Amendments to the Drawings:

This paper is responsive to the Office Action mailed April 19, 2006. Claims 1, 2, 10, 11, 16, 22 and 23 have been amended. Support for all amended claims can be found in the specification, and no new matter has been added by these amendments. Claim 24 is cancelled. Claims 1-23, 25 and 26 are currently pending in the above-identified application. Reconsideration of the claims in view of the amendments and the following remarks is respectfully requested.

ANNOTATED SHEET
Application No. 10/769,388 -- Attorney Docket No. 019680-007200US

Fig. 3

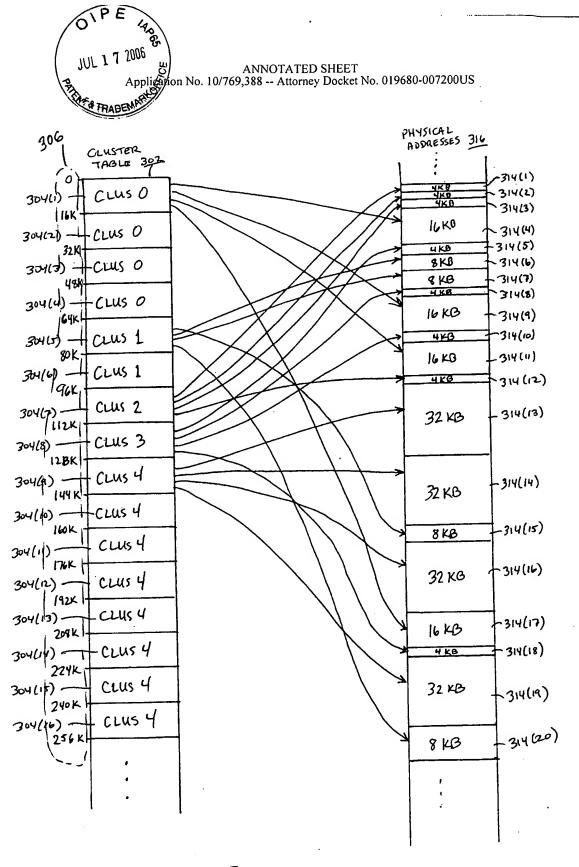
The Examiner has objected to Figure 3 for failing to comply with 37 C.F.R. §1.84(p)(5). Figure 3 has been amended to include reference number 306. Applicants have further amended Figures 1, 10, 20 and 24 to include appropriate reference numbers and flow diagram labels as shown in red on the attached Annotated Sheets. Withdrawal of the objection to the drawings is respectfully requested.
